NSRP #0349
May 1992

P-52 Balloting of Hull
and
Mechanical Standards

Panel SP-6

FIGURE 1

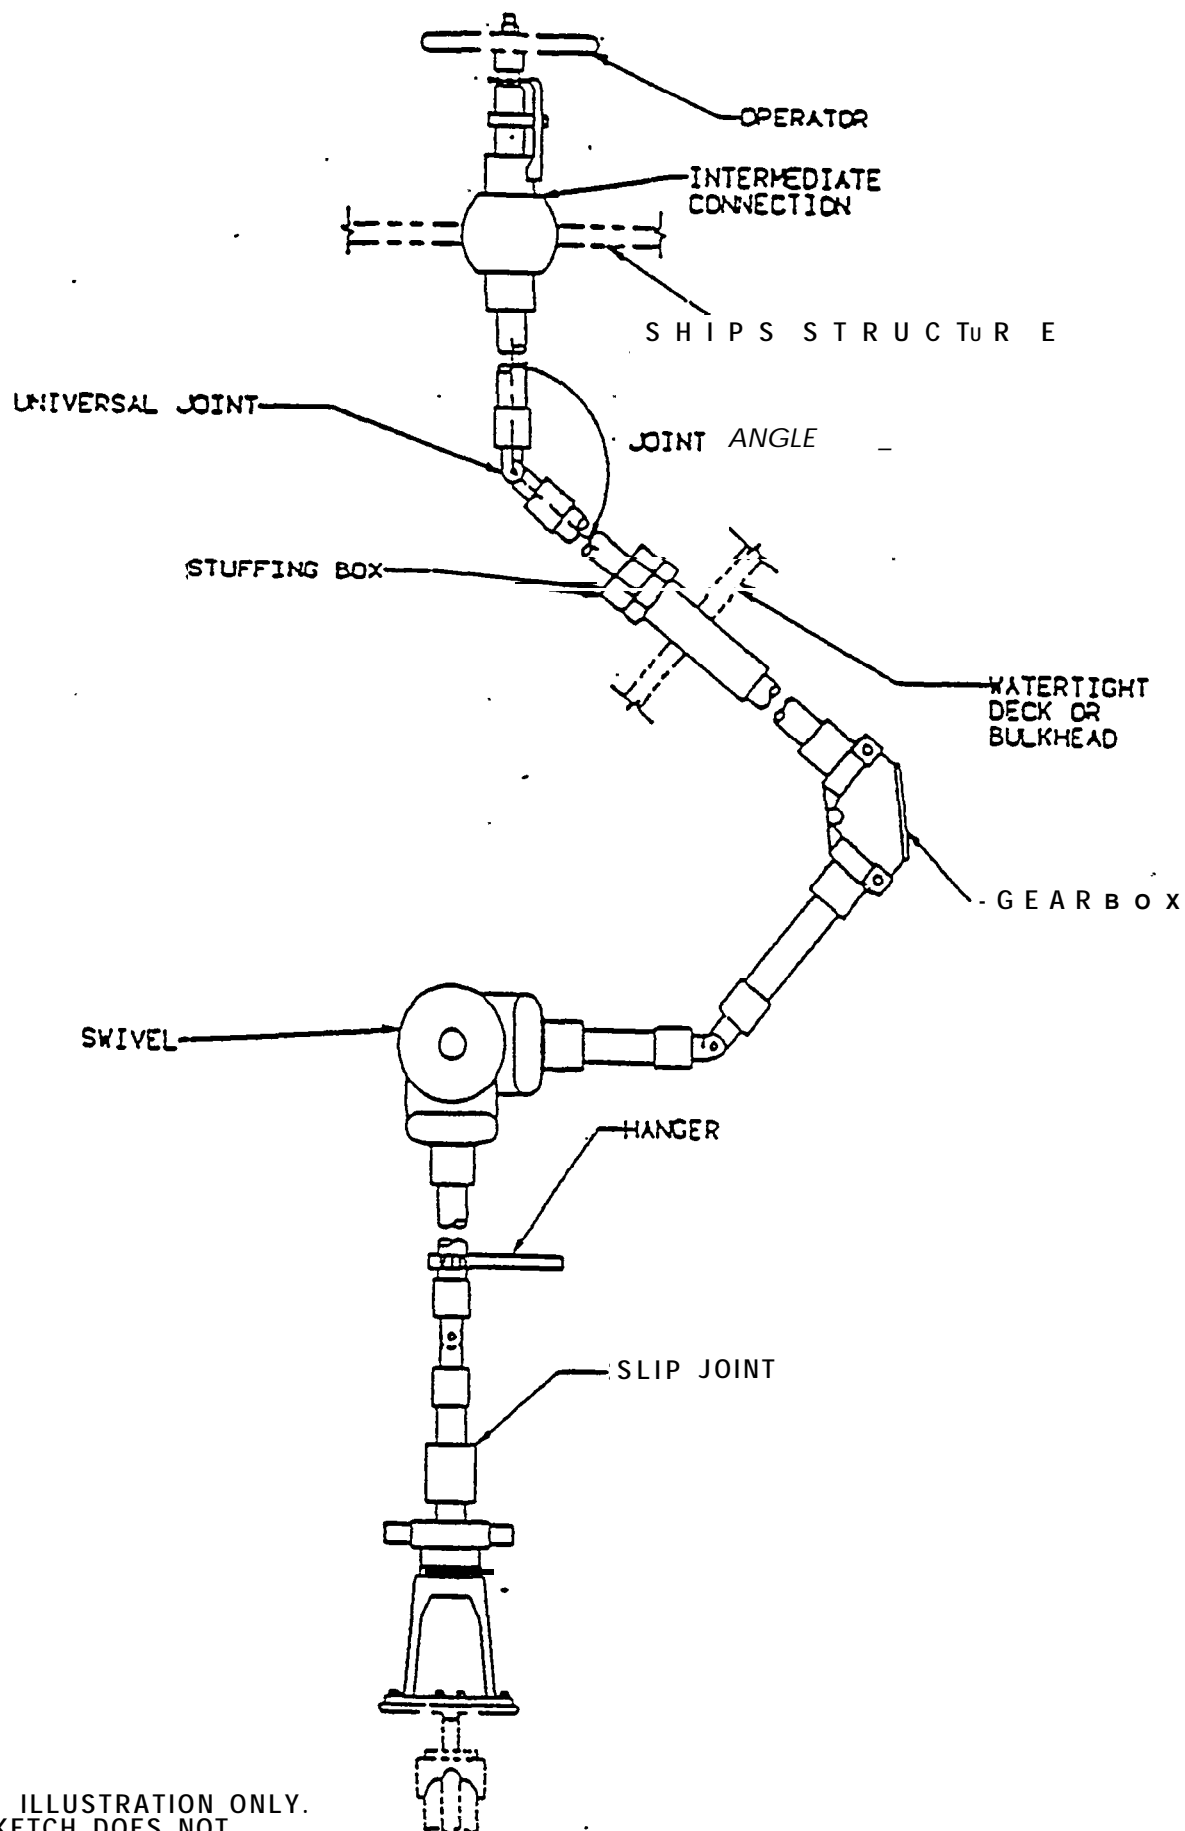
| 31. Figure 1 - What is Fig.1 intended to convey?..... | Universal Joint efficiency to be read in conjunction with Table 1. |

FIGURE 1. WATER TRAP FORD DIESEL EXHAUST

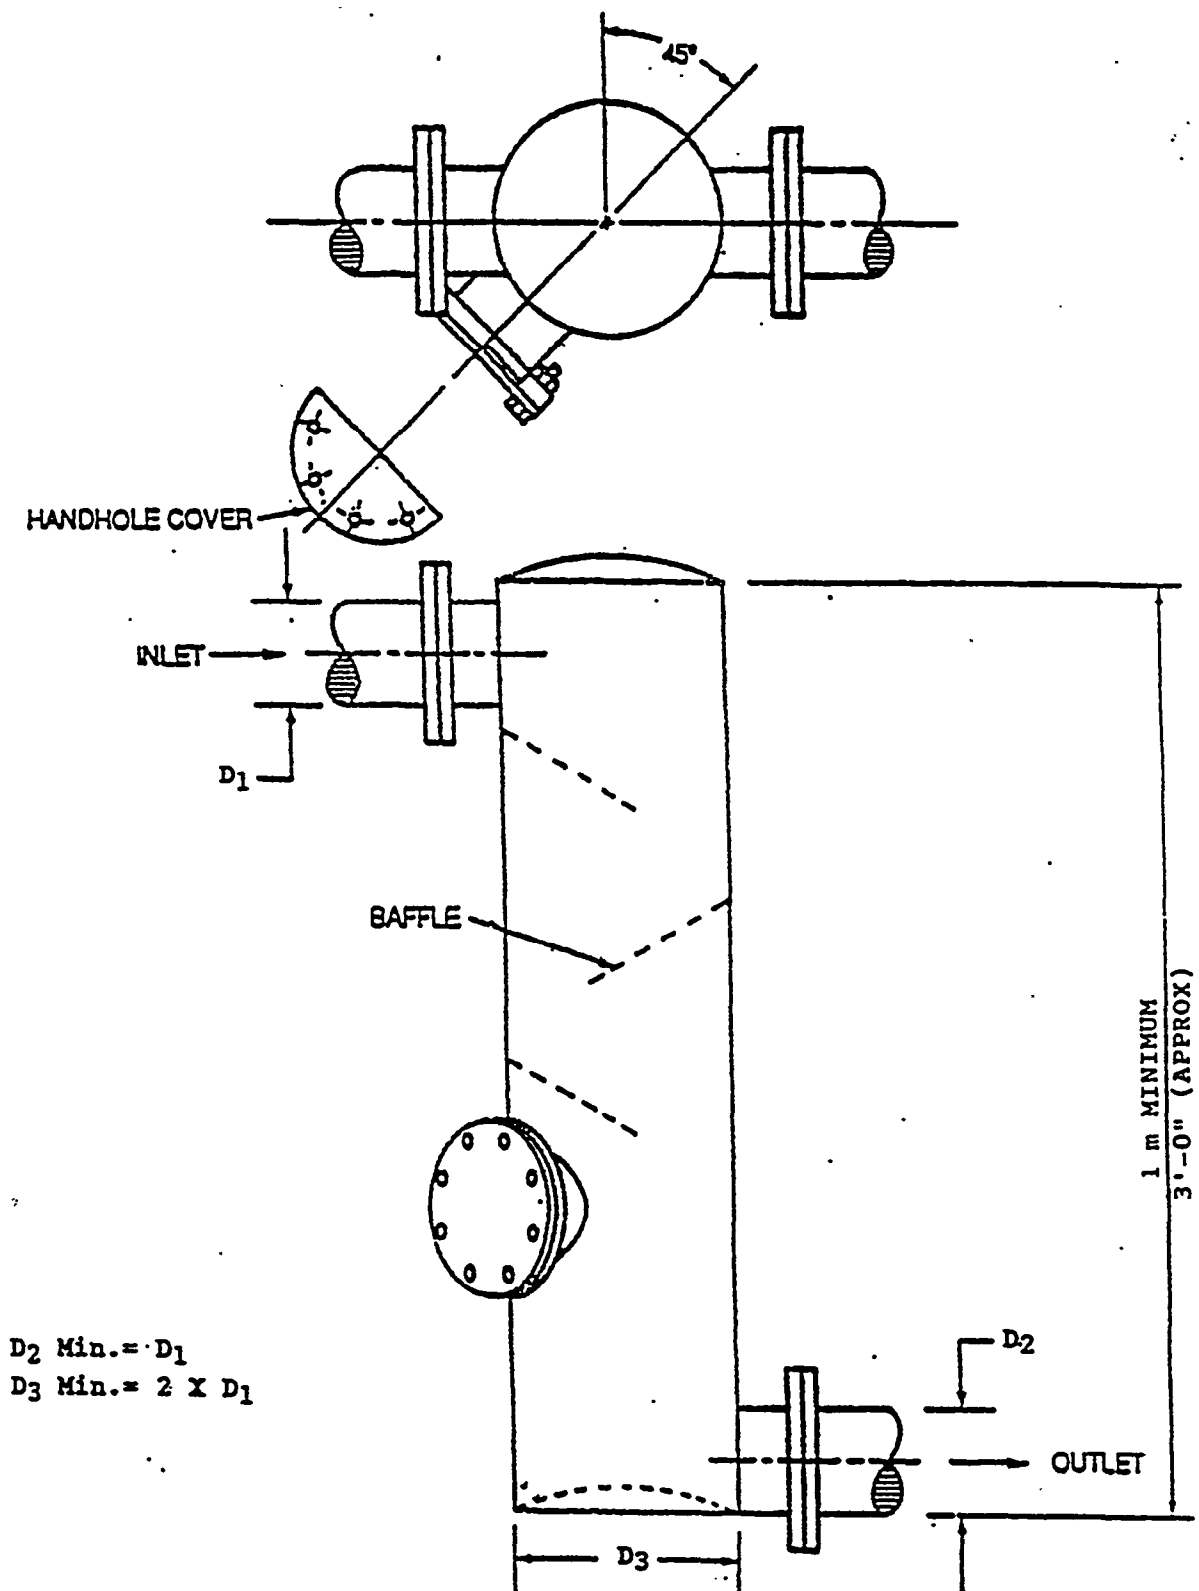
| 5. Fig. 1 -.There is no need to show 4" & 8" dimensions, since Para 5.3.2 indicates trap diameter equals twice the inlet dia. | Concur |

4. Fig.1 - (a) Delete handhole serves no purpose.

8. There is no need to show 4" (100mm) a 8" (200mm) on Fig-1. per para 5.3.2 the trap dia equals to twice the inlet dia...

| 33. Fig.1 - Correct. min. dimension to read "1 m minimum (3' approx)." | Concur - See Comment (6) |

FIGURE 1

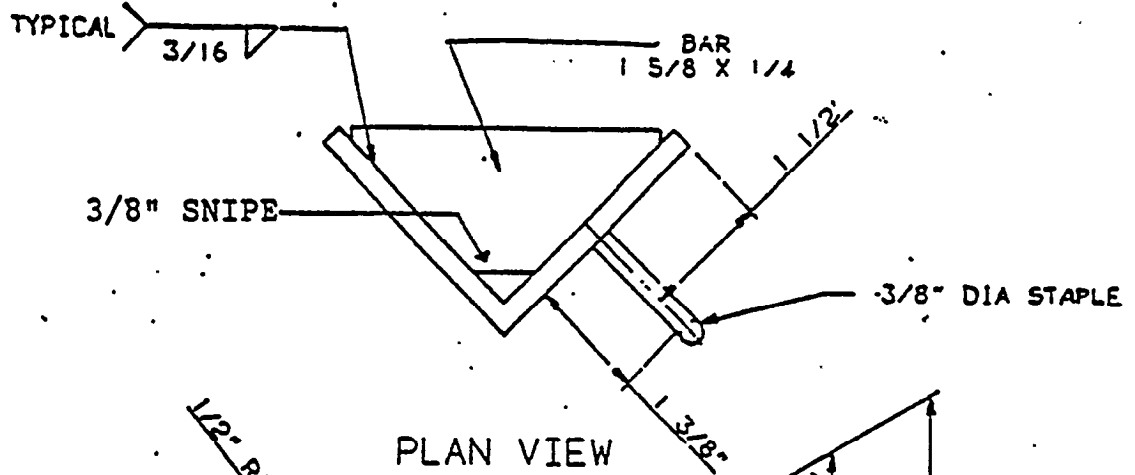
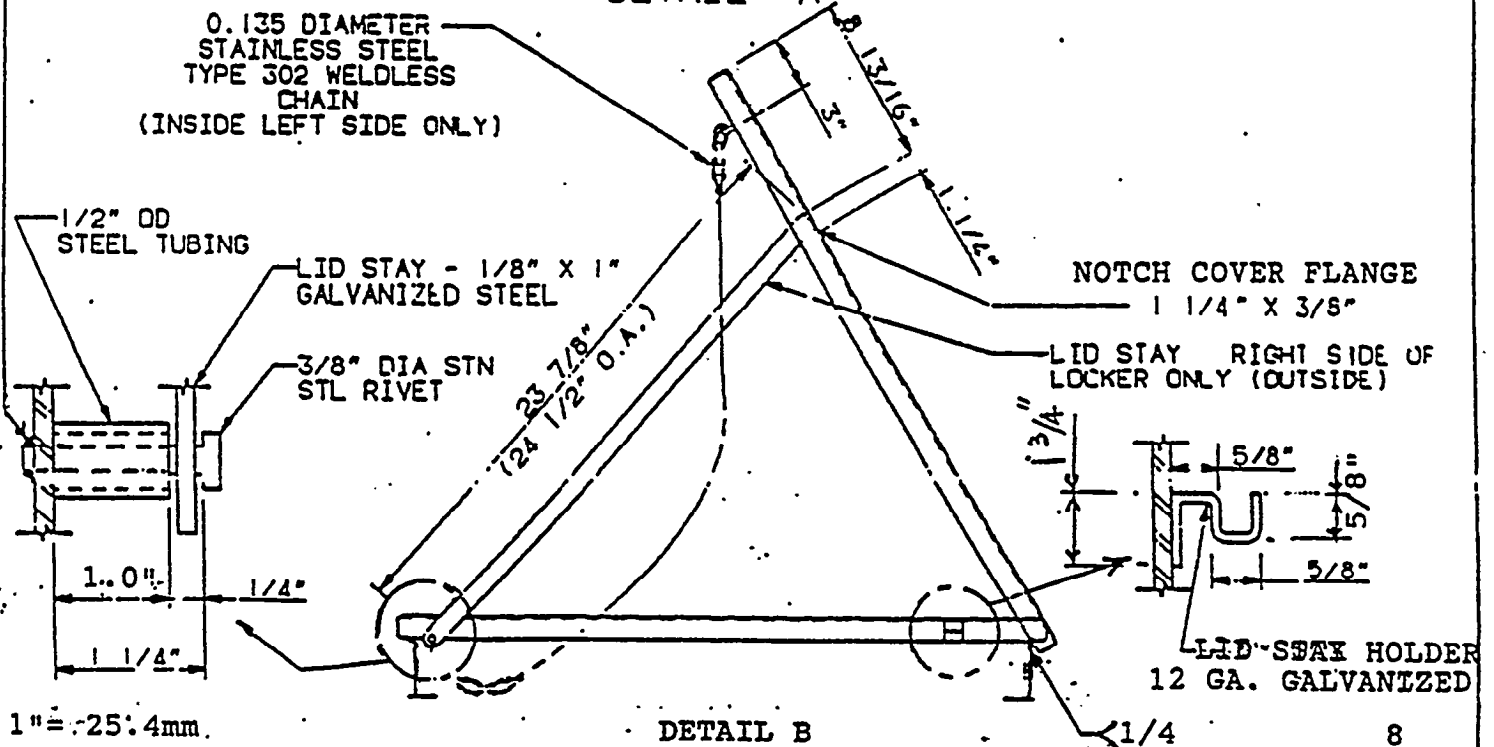
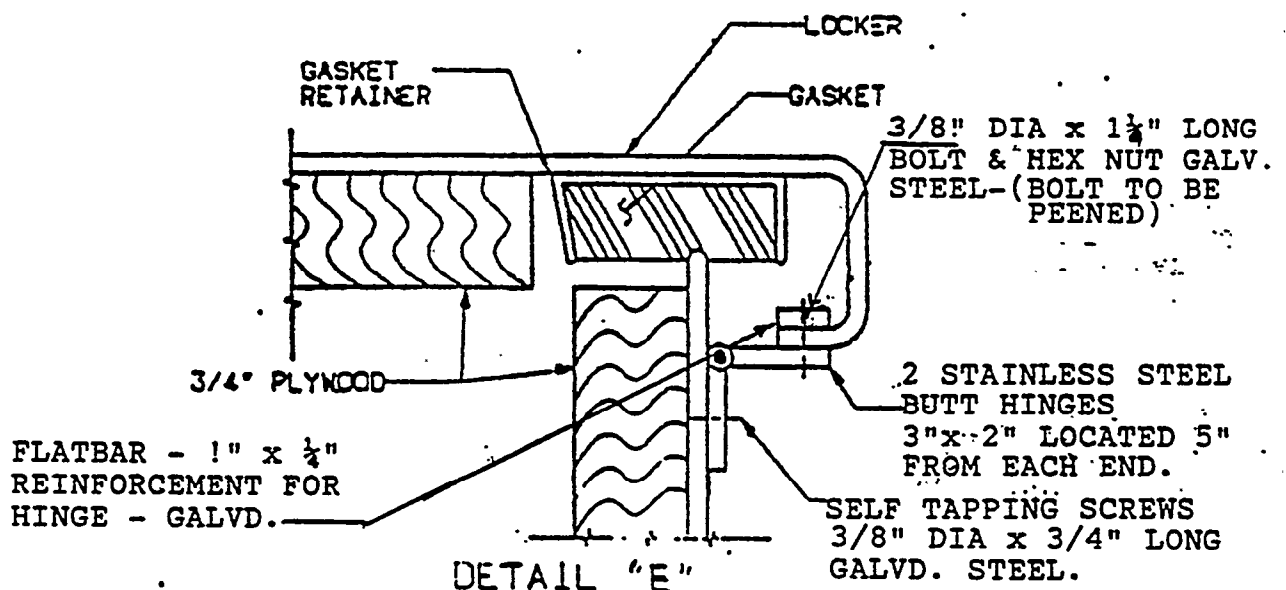
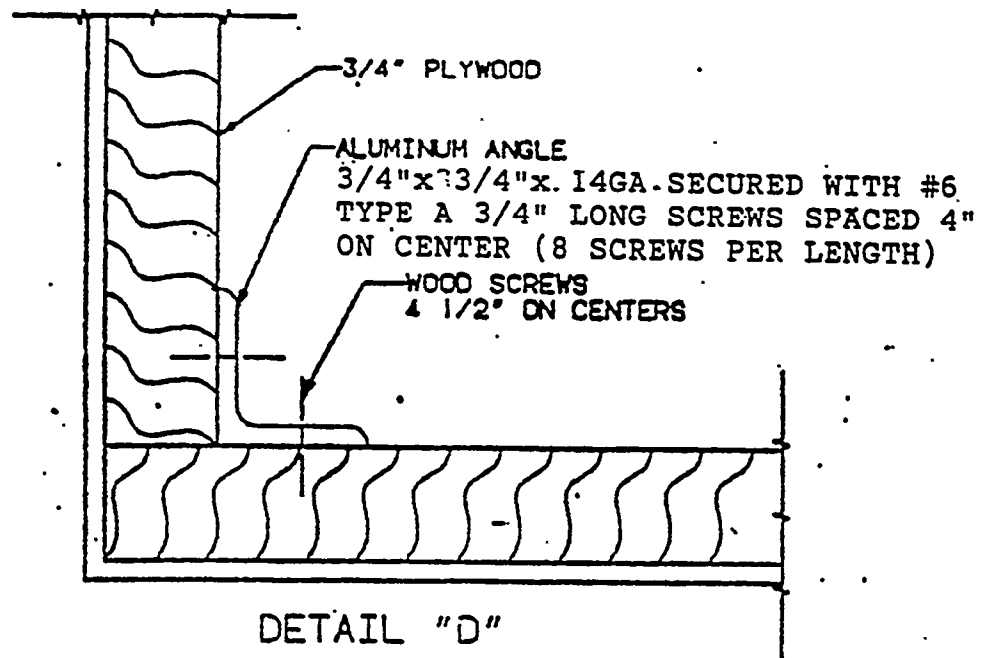
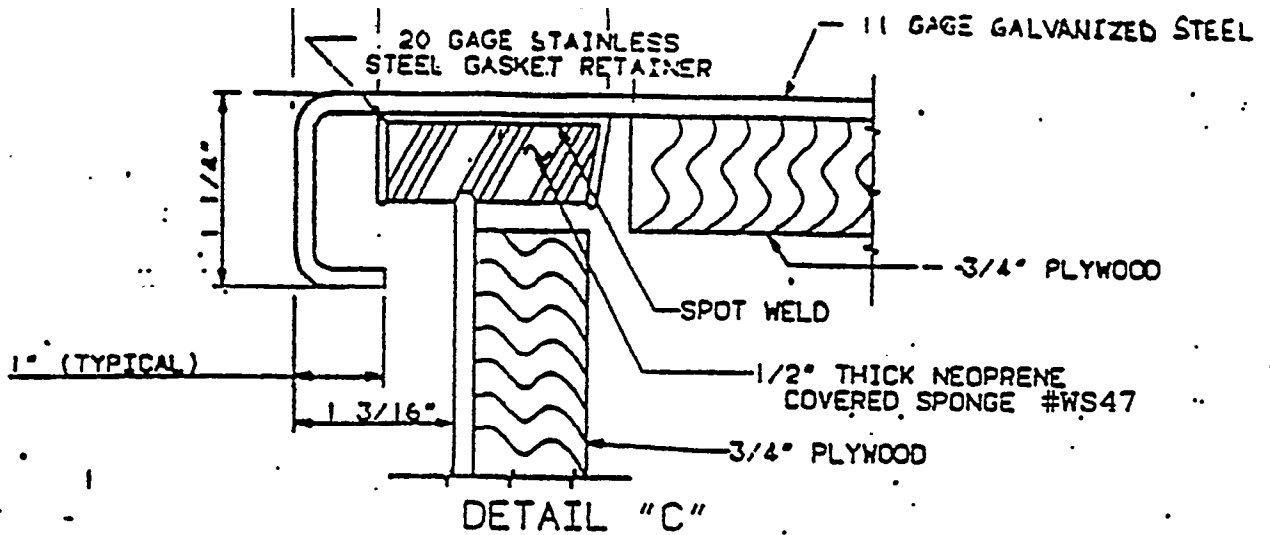
19. Fig.1 - Label: Based on response to comment 18, I assume this is a stencil. Requirement should be clarified by a Para in the text.

20. Fig.1 - Change "Inflammable" to "flammable".

9. Fig.1 - Shows red lettering on the front. face of locker which conflicts with 44 CFR 176.150 (a) (7) which requires lettering on the top & four sides - recommend to revise Fig.1

FIGURE 1
LIGHT DUTY DAVIT
TYPE I

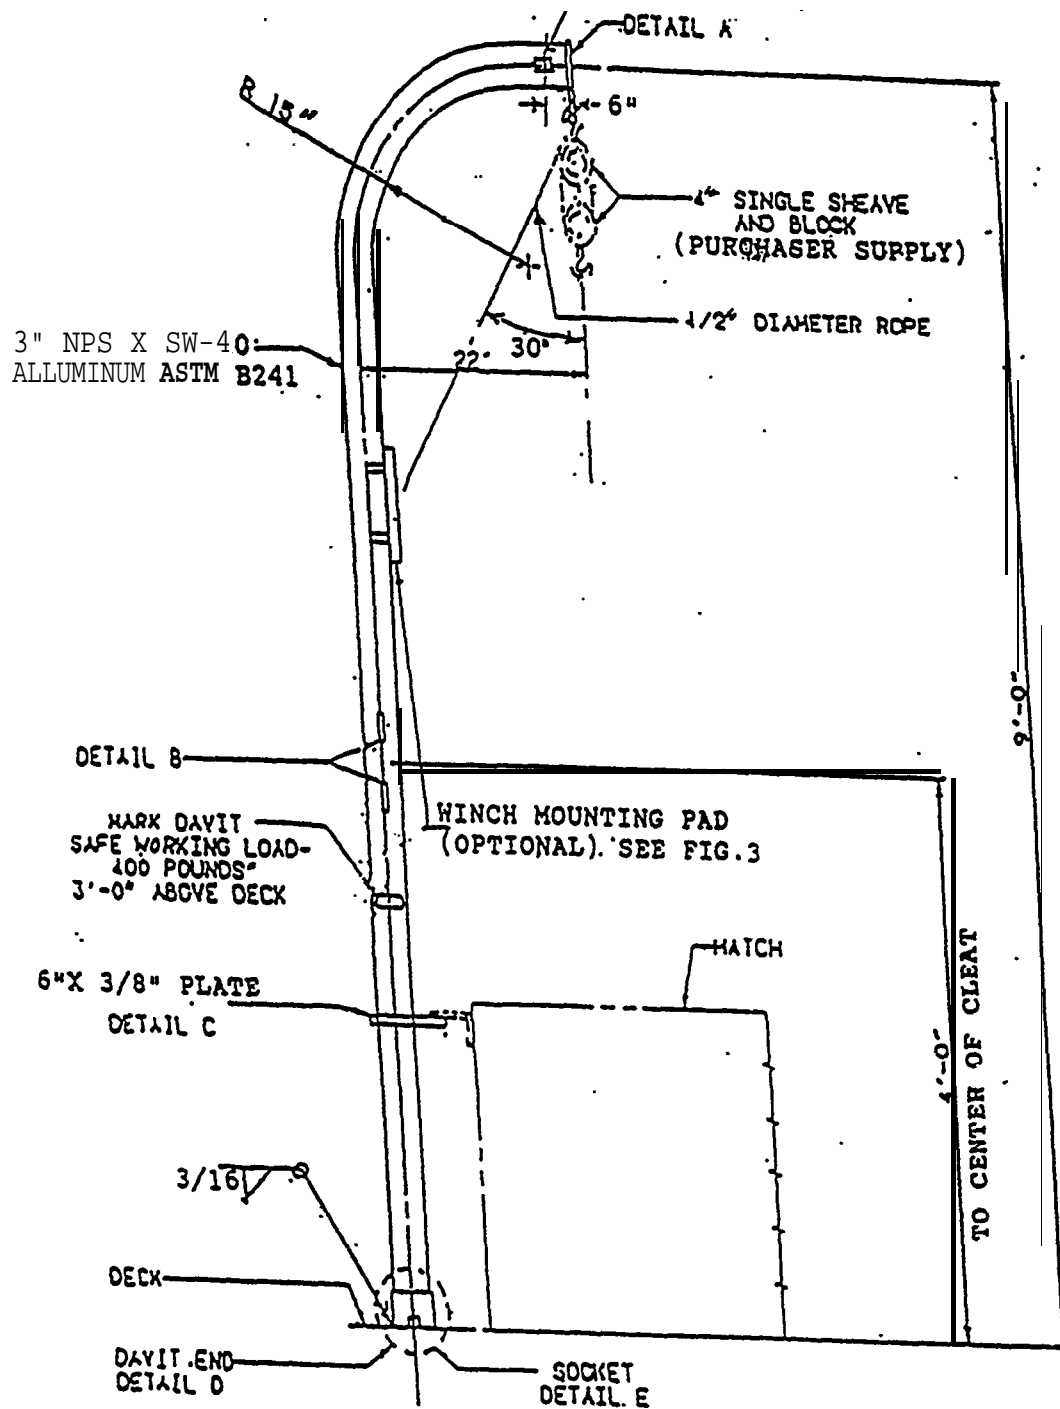
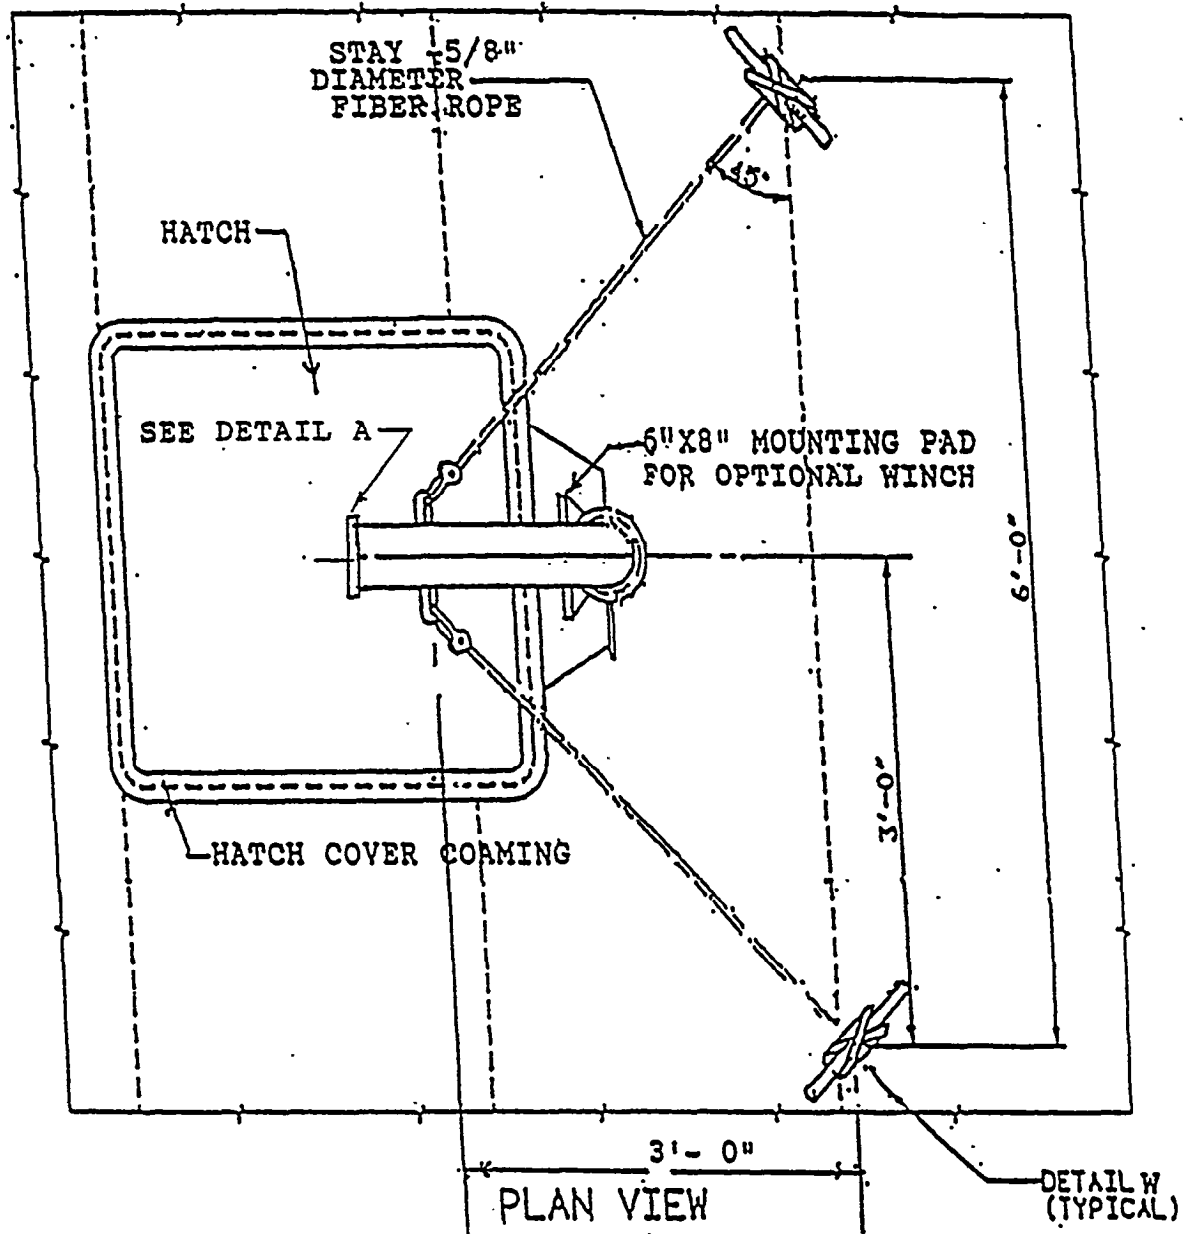
24. Figure 1 - Indicate whether rope sheaves & block are supplied with davit.

25. Indicate detail "B" as cleat in Fig. 1.

27. Add alternative pedestal support in lieu of hatch in Fig. 1.

28. Indicate detail C in Fig. 1. "where applicable" if used in conjunction with a hatch and add separate pedestal details.

| 44. Fig. 1 - Is the socket welded to the deck? If so, what is the weld? How is the socket protected when not in use? | Socket welded to deck. For details of weld, see detail E. Protection of socket left to the ship. |
| 45. Fig. 1 - Det.C - If this is welded, how is it portable? | The hatch cover mounting plate is bolted to hatch cover - Also material has been identified in this detail. |
